Year Two Monitoring Report

GROUNDHOG HOLLOW PROJECT

NCDMS Project #100049 (Contract #7417) | RFP 16-007277 (Issued 6/21/2017)

RE: Groundhog: Year 2 Monitoring Report (NCDMS ID 100049)

Figure 2 - CCPV MY2
Groundhog Hollow Mitigation Project
Alexander County, North Carolina

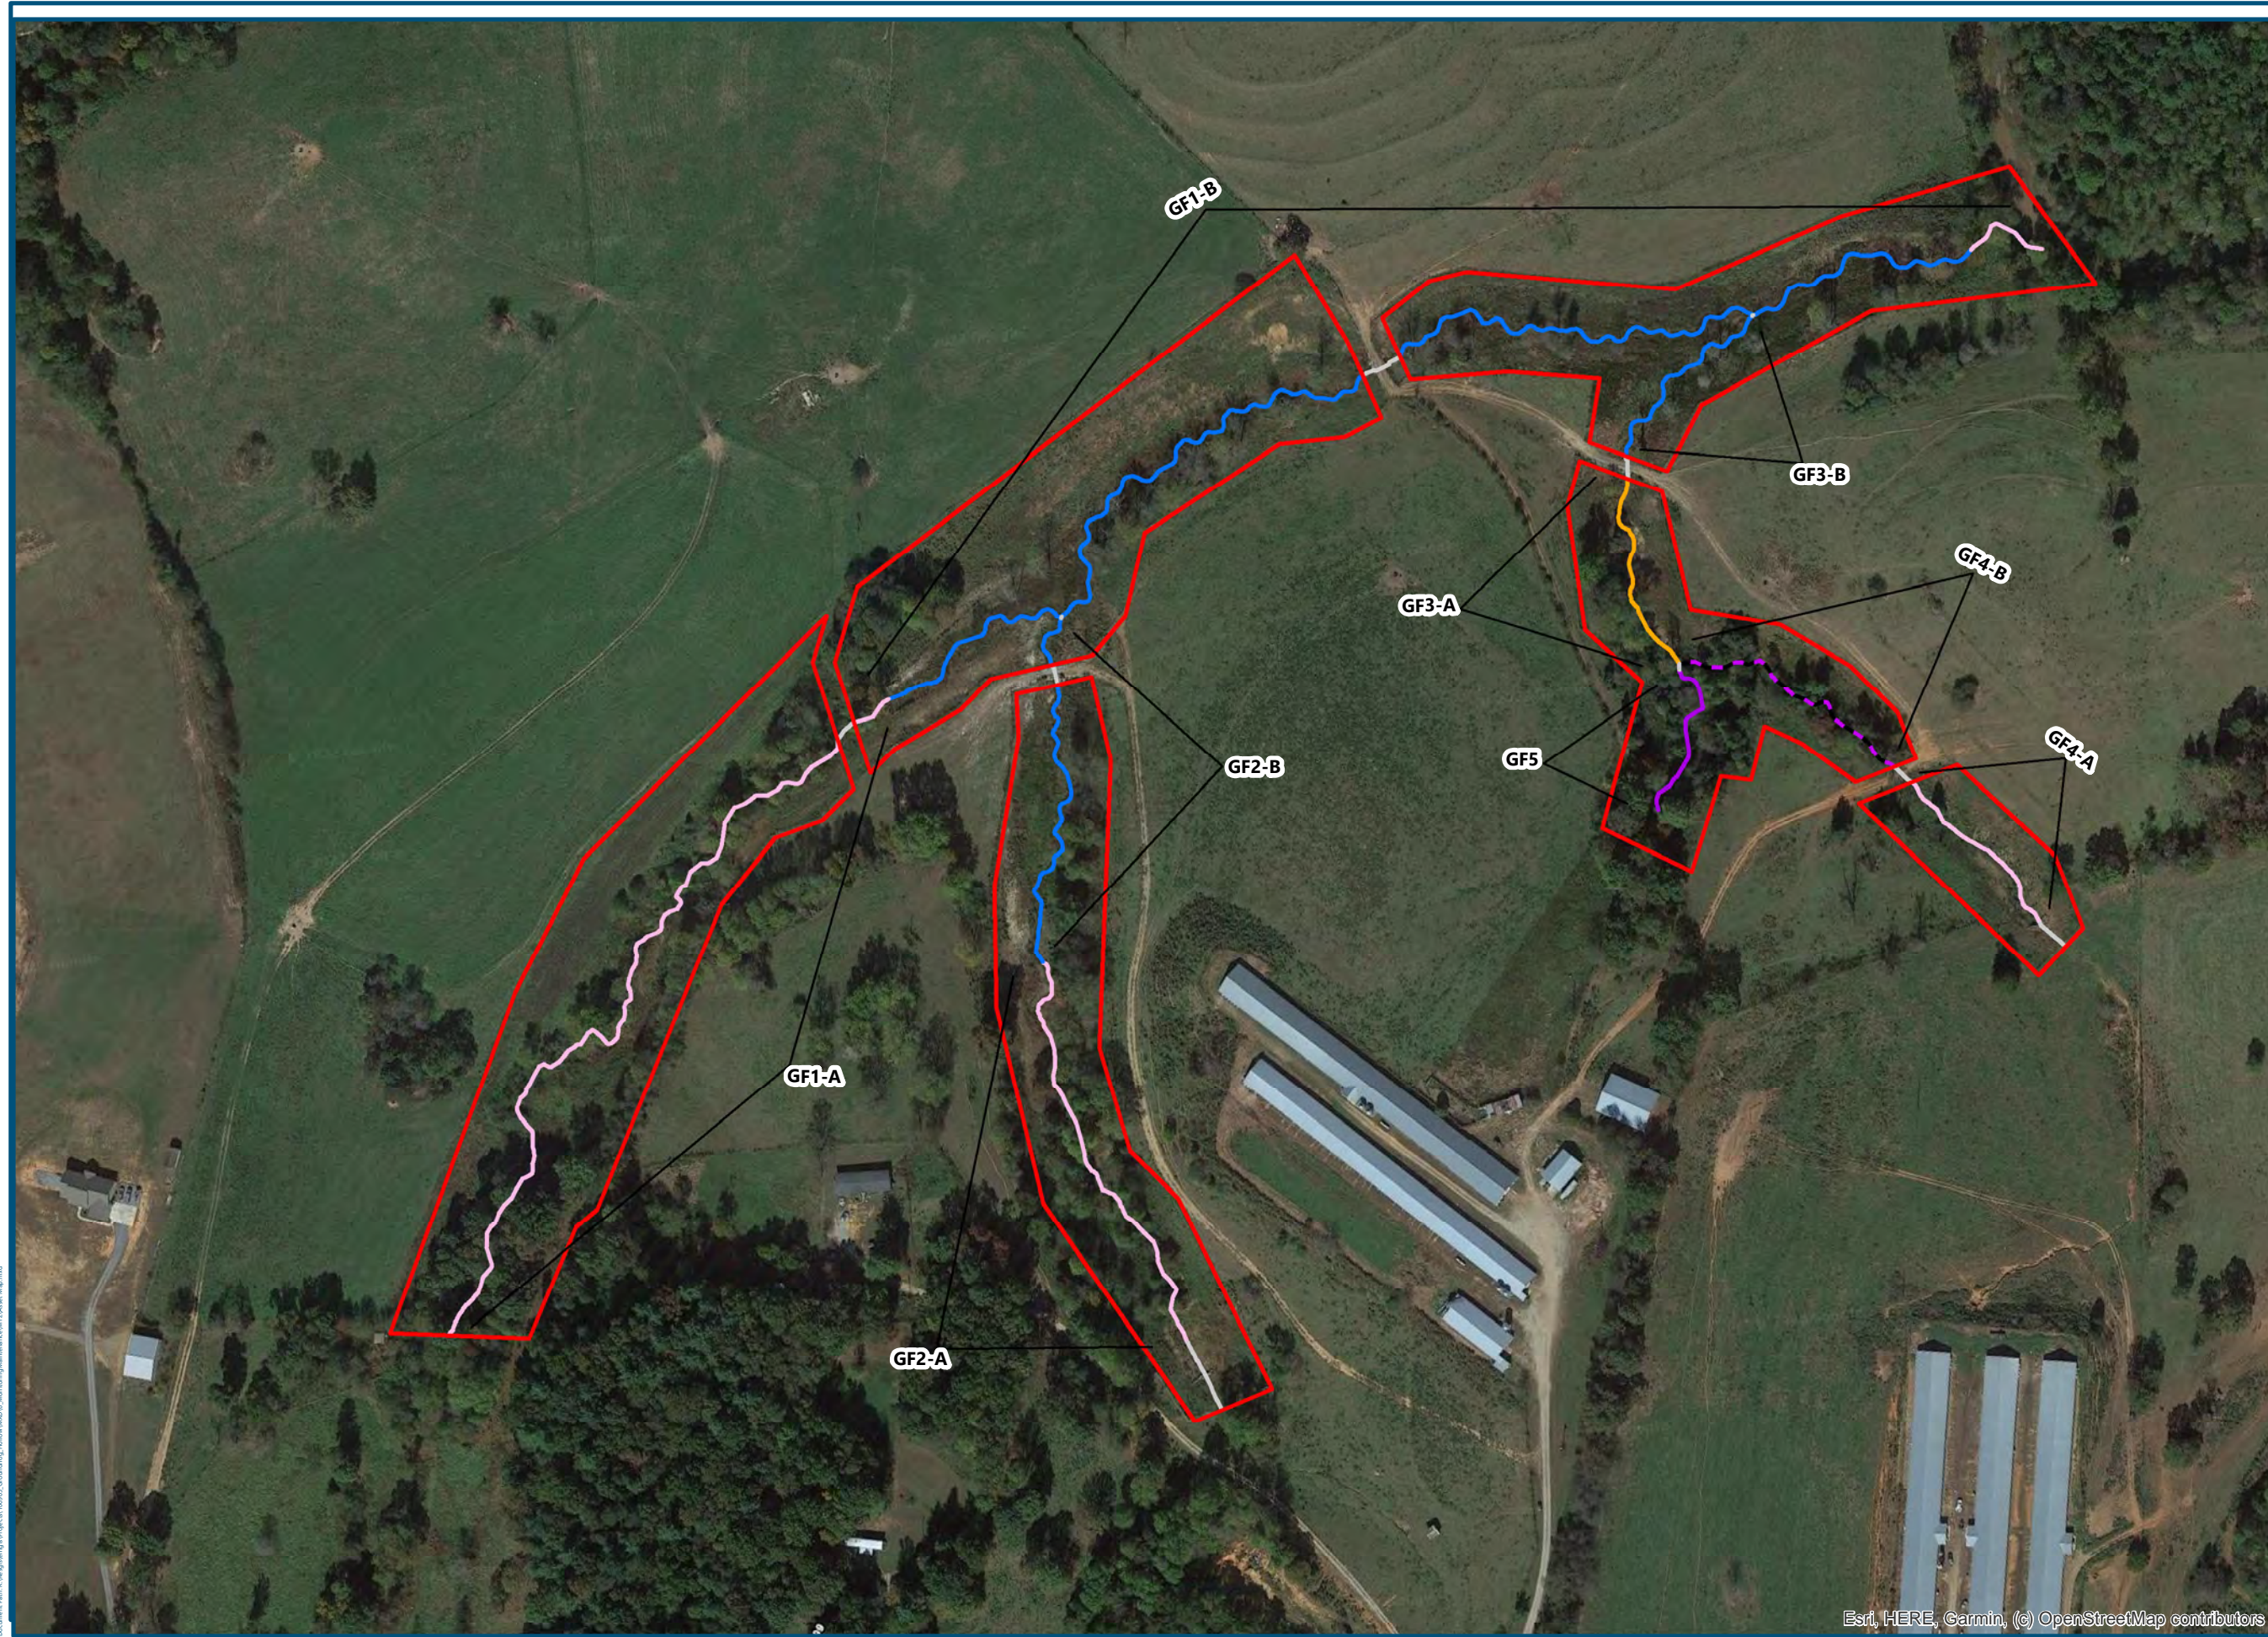
- Table 4 – Project Background Information: Please include the reaches' thermal regime (warm) in the table.
[Done.](#)
- CCPV Map: Please show the stage recorder reported on GF2-B on the CCPV Map. Please update the “Deteriorating Structure” map call out to “Deteriorating Stream Structure” to avoid confusion with a dilapidated building potentially being located within the conservation easement.

- Report Text/ Table 6/ CCPV Map: The report text indicates that approximately 0.21 acres of Chinese Privet was “flush cut” in MY1 and will require further invasive treatment in 2023. Chinese privet was also noted along GF1-A, GF1-B, GF2-B, and GF4-A during MY2 and is proposed for treated in 2023. Table 6 shows 0% invasive areas of concern and the CCPV maps provided in the draft report are not consistent with the report text in Section 1.7. Please review the report text, tables and CCPV Map and update them so the invasives reported on the project site are consistent through the final MY2 document. The report body and Table 6 has been updated with the correct acreage of Chinese privet of 0.26 acres not 0.21 acres as originally stated. The concentrations of Chinese privet have been noted on the CCPV, however there are scattered stems along GF1-A, GF1-B, GF2-B, and GF4-A.

The stage recorder is present on the CCPV however is obscured by the XS 18 label and can be hard to see. The gage has been shifted slightly on the figure for clarification. The stream structure callout has been updated.

Figure 3 - Supplemental Planting MY2
Groundhog Hollow Mitigation Project
Alexander County, North Carolina

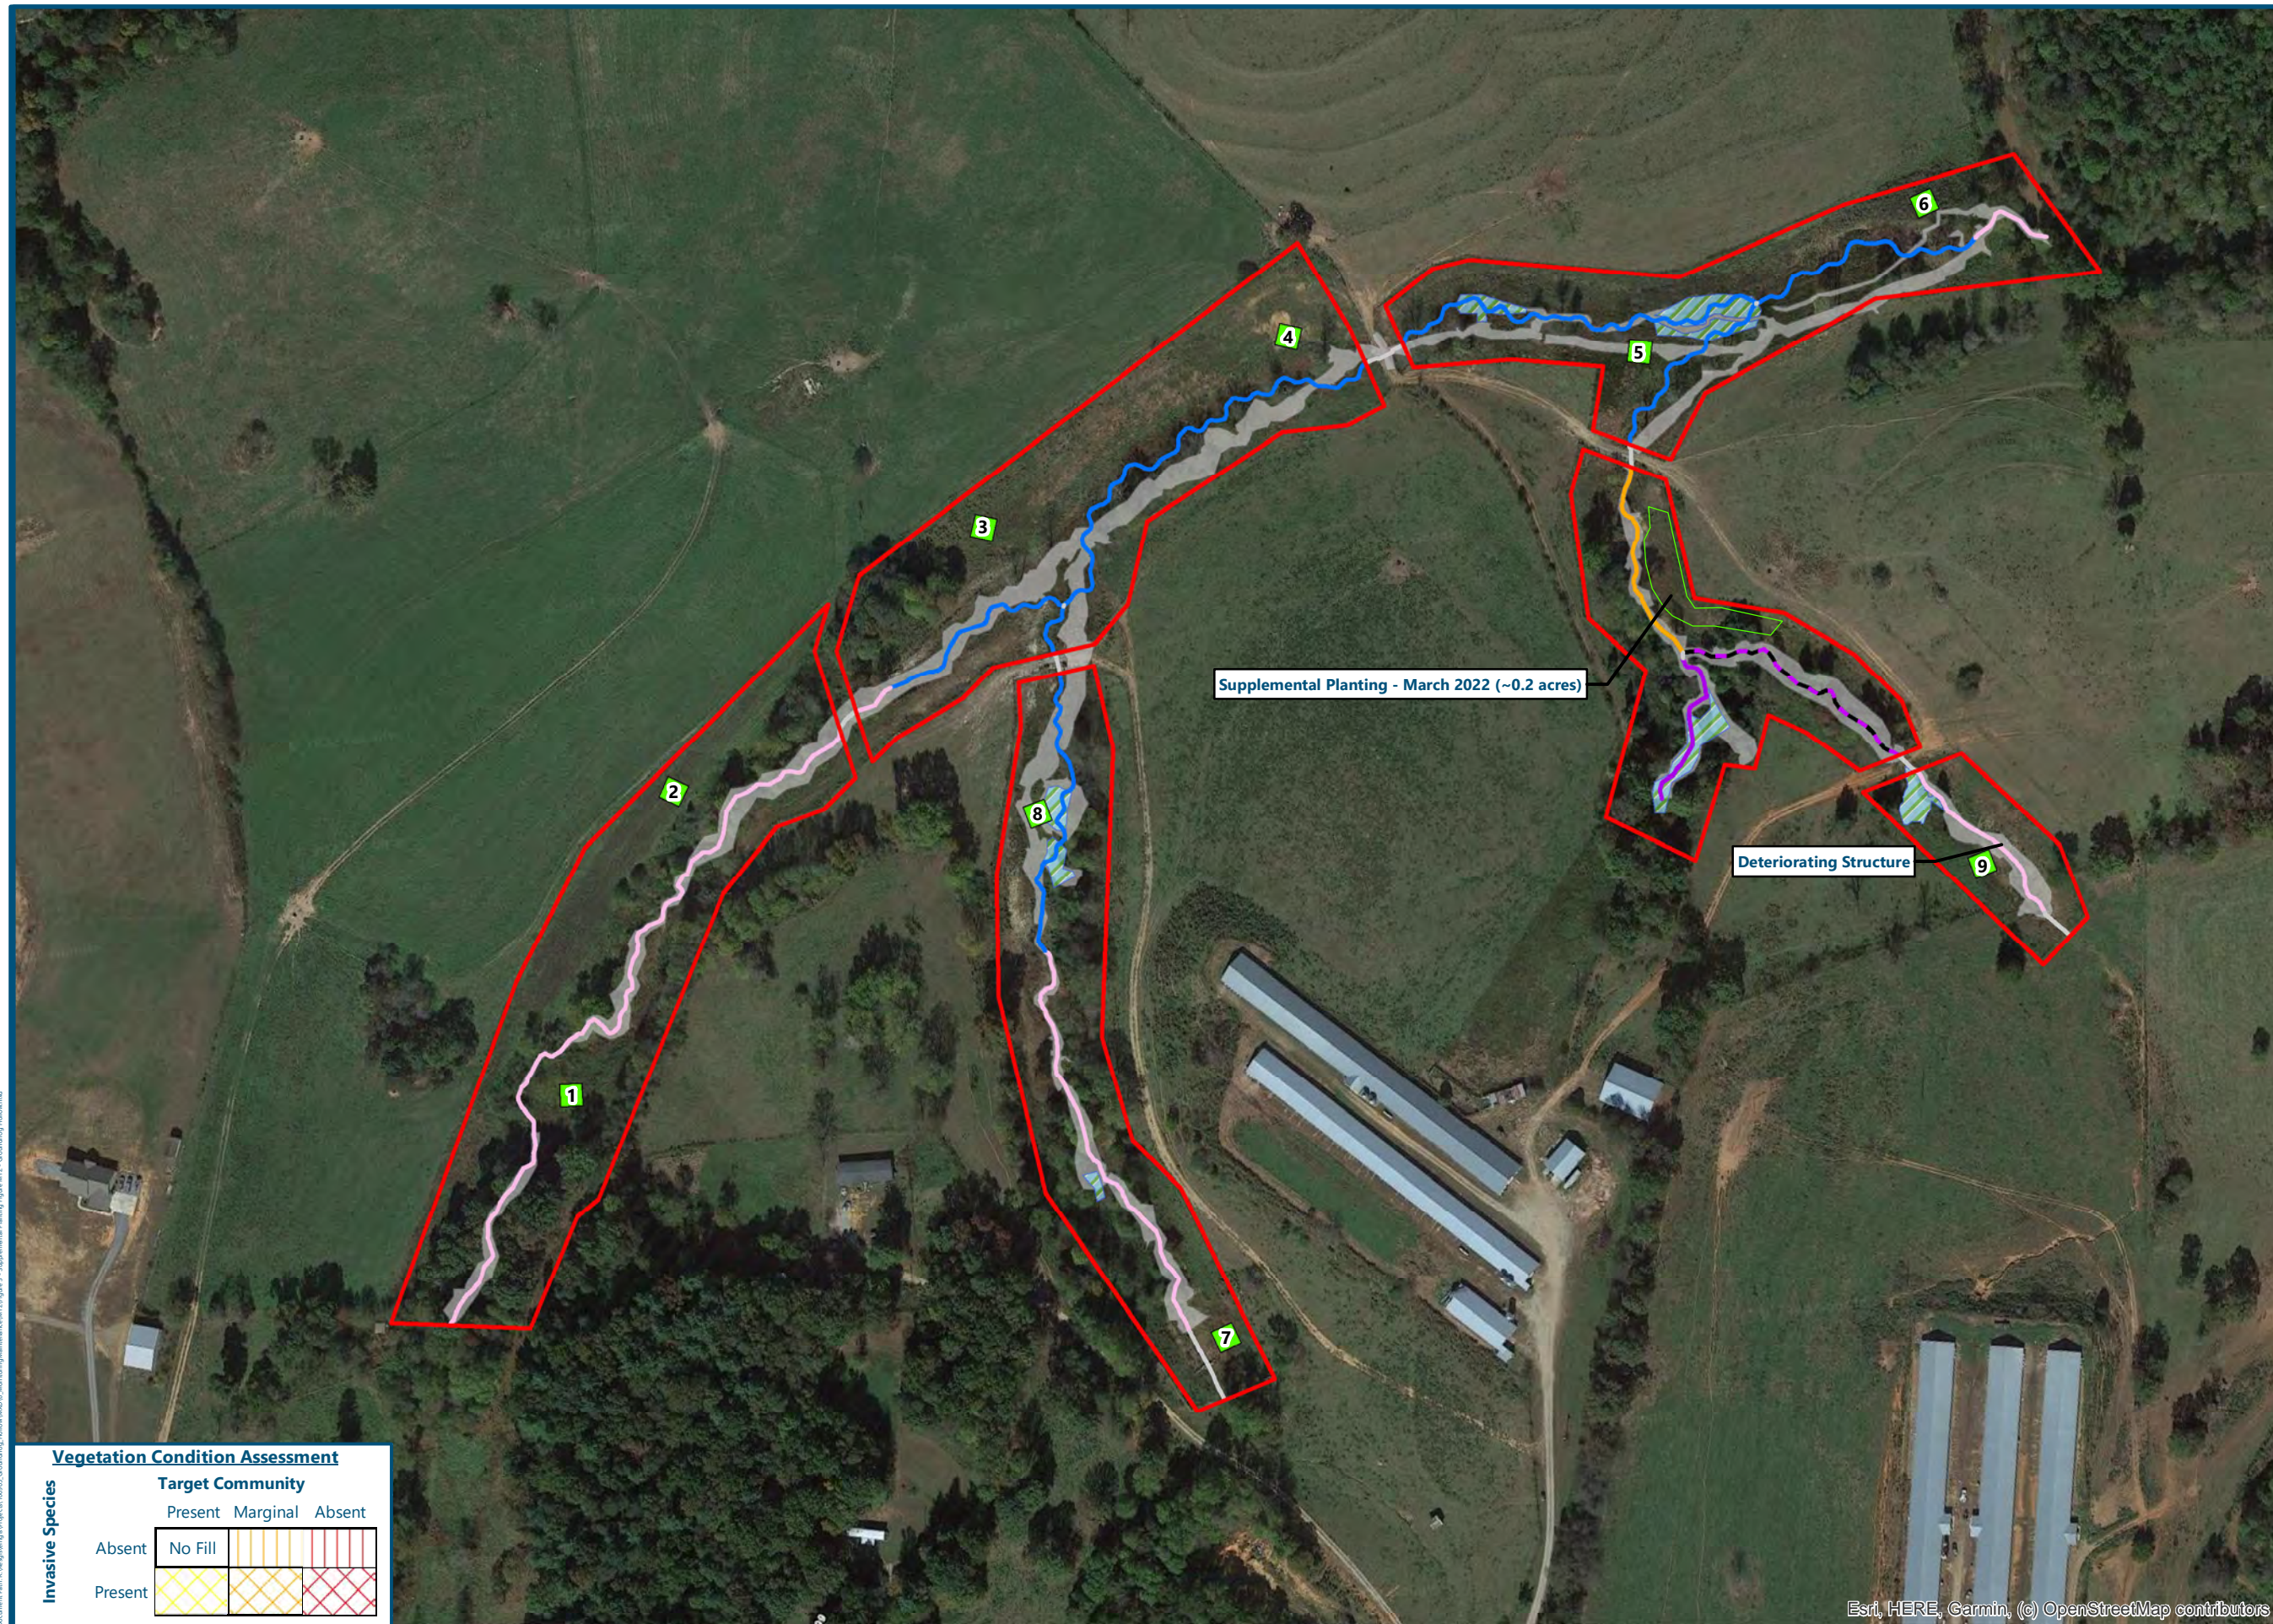
- Section 1.7 Monitoring Performance (MY2) – Vegetation: Please provide a separate MY2 (2022) supplemental planting list and supplemental planting map in the report appendices. The supplemental planting list should also include the wetland indicator status for the species.
[A supplemental planting figure and summary table have been added to Appendix C.](#)
